<b>.,Ltd.</b>		
<b>Intel BDWU</b>		
Size	Document Number	Rev
	<b>XX</b>	<b>V1</b>
Date:	Monday, October 12, 2020	Sheet 8 of 49

<b>.,Ltd.</b>		
File <b>Intel BDWU</b>		
Size	Document Number <b>XX</b>	Rev <b>V1</b>
Date:	Monday, October 12, 2020	Sheet 13 of 49

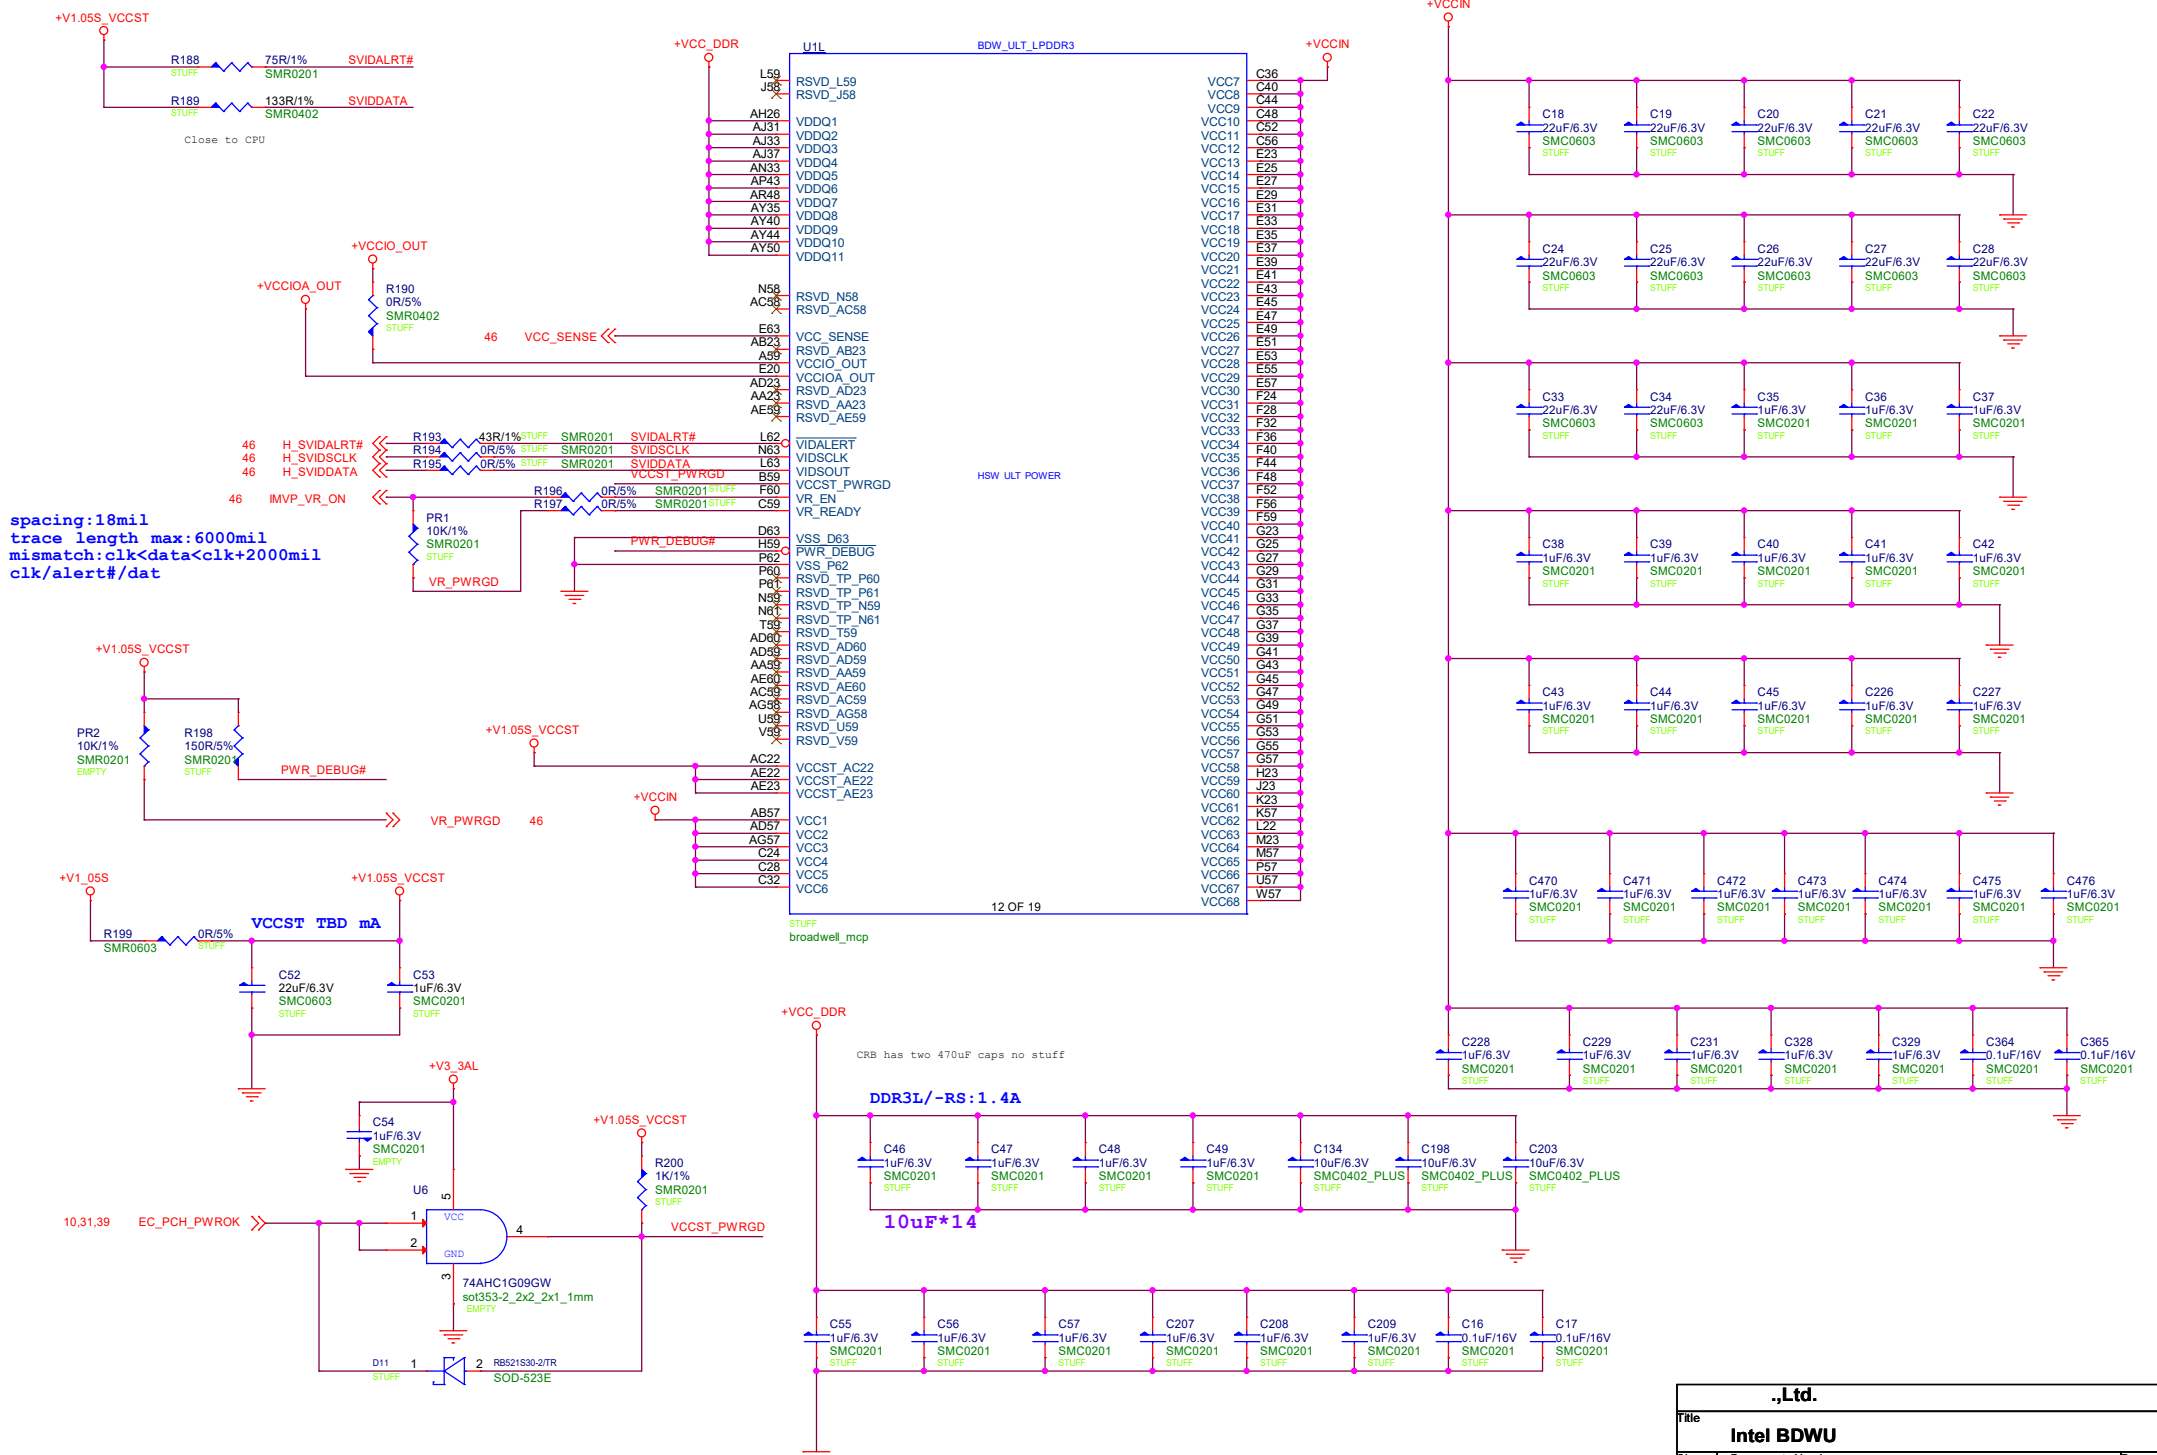
Check list use 120 CRB 75  
Intel confirm 120 Ohm

spacing:18mil  
 trace length max:6000mil  
 mismatch:clk<data<clk+2000mil  
 clk/alert#/dat

CRB has two 470uF caps no stuff

DDR3L/-RS:1.4A

10uF\*14

calculated 32A  
IccMax. Adjust  
F-IMAX divider  
for 40A.

<b>Intel</b>	
<b>Intel BDWU</b>	
Docu	Docu
Number	Number
<b>XX</b>	<b>V1</b>
Date: Tuesday, October 13, 2020	Sheet 46 of 49

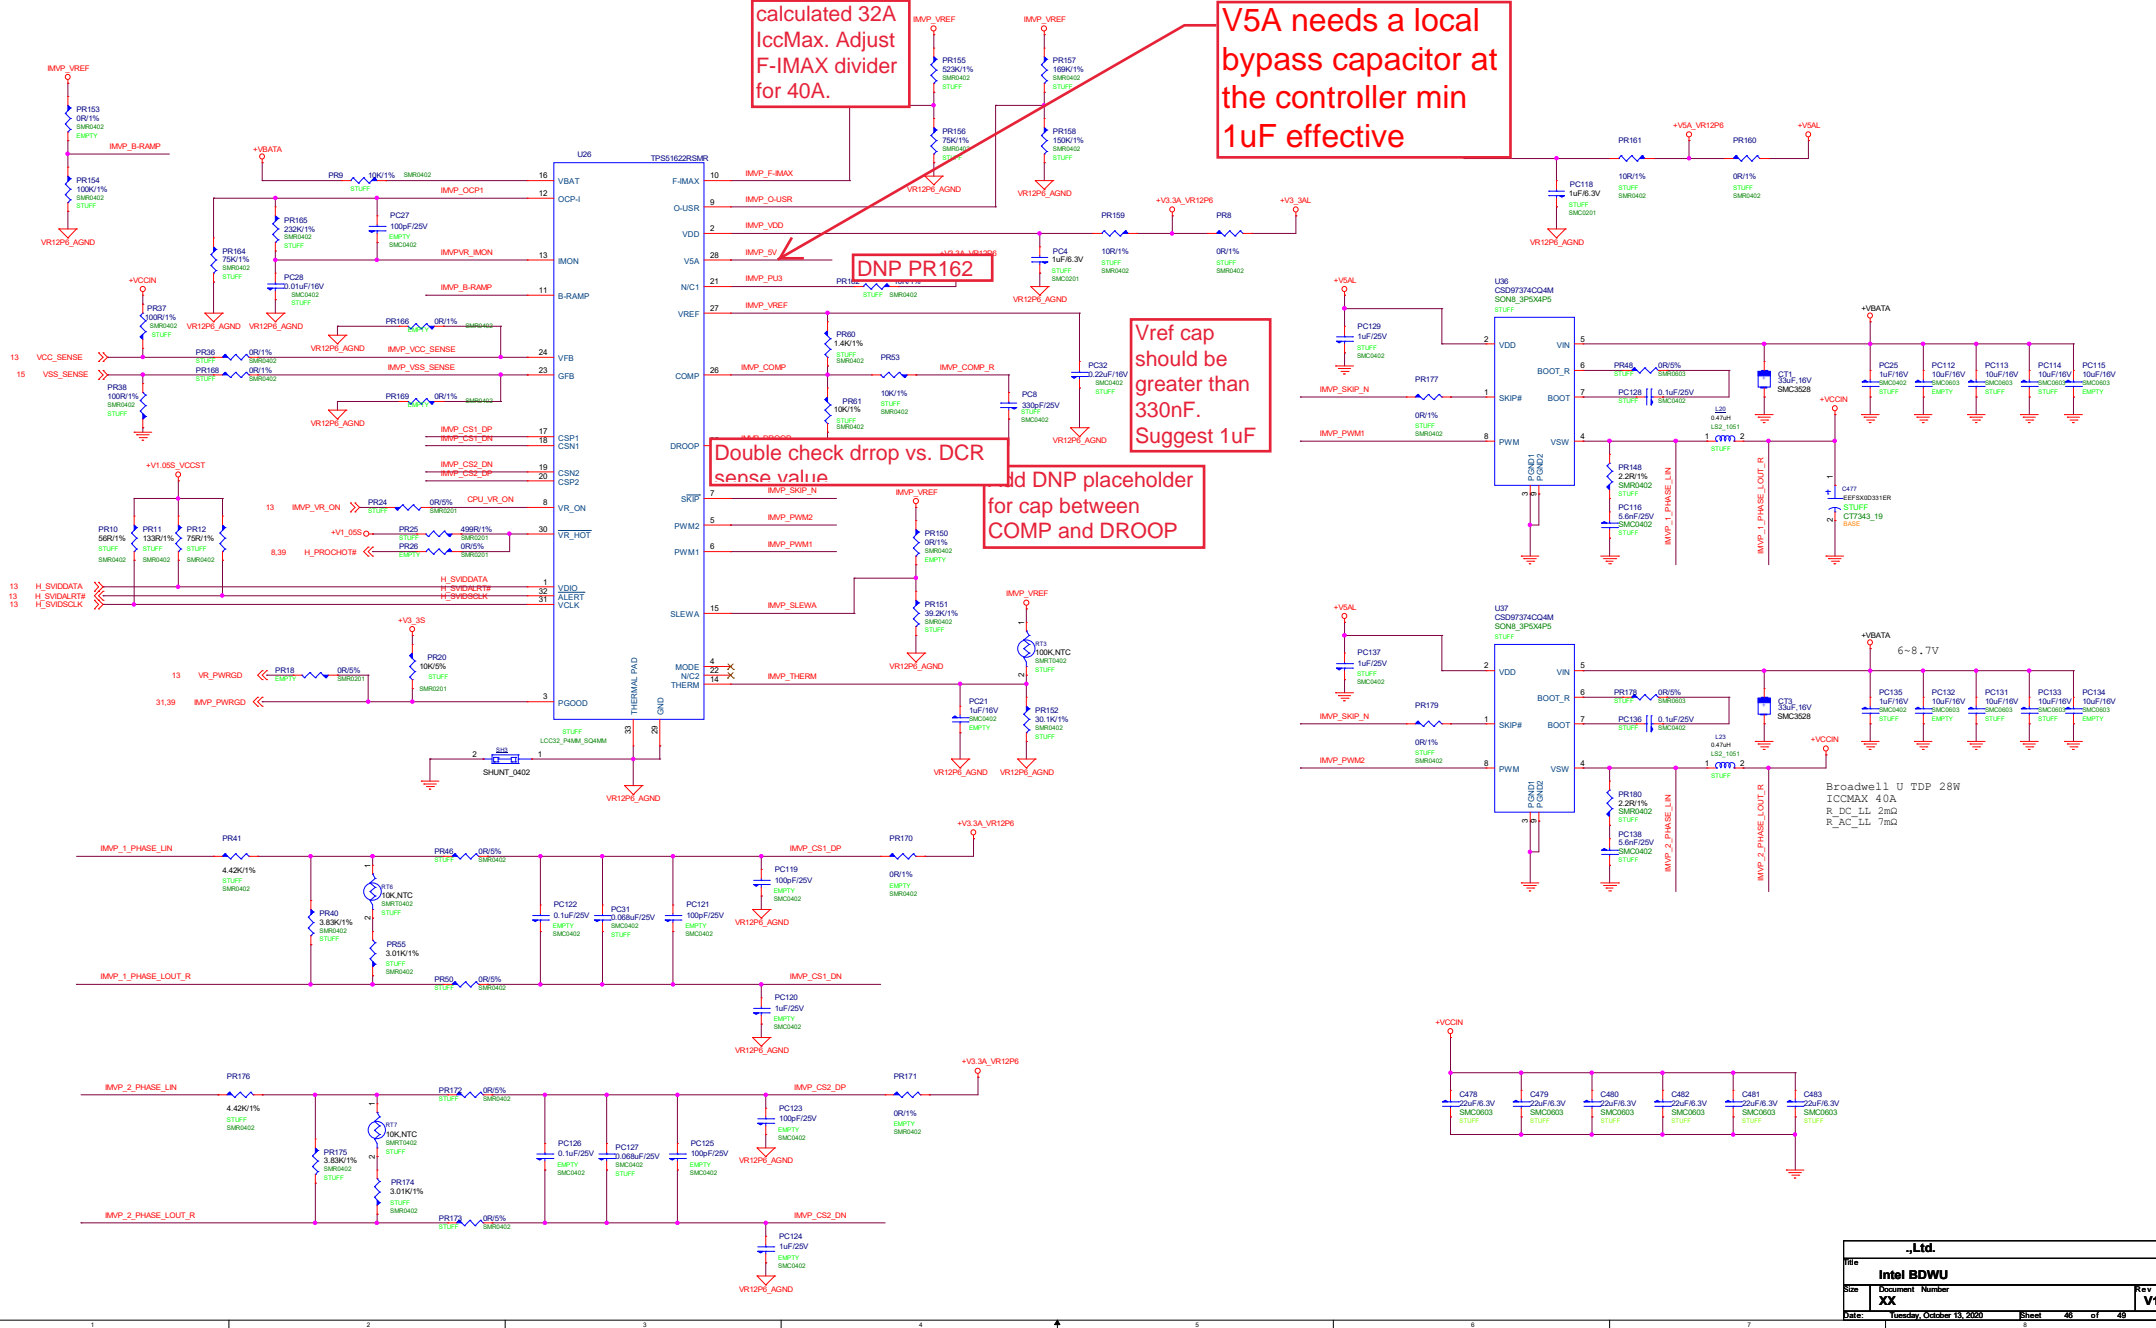
V5A needs a local  
bypass capacitor at  
the controller min  
1uF effective

DNP PR162

Vref cap should be  
greater than  
330nF.  
Suggest 1uF

Double check drop vs. DCR  
sense value

add DNP placeholder  
for cap between  
COMP and DROOP
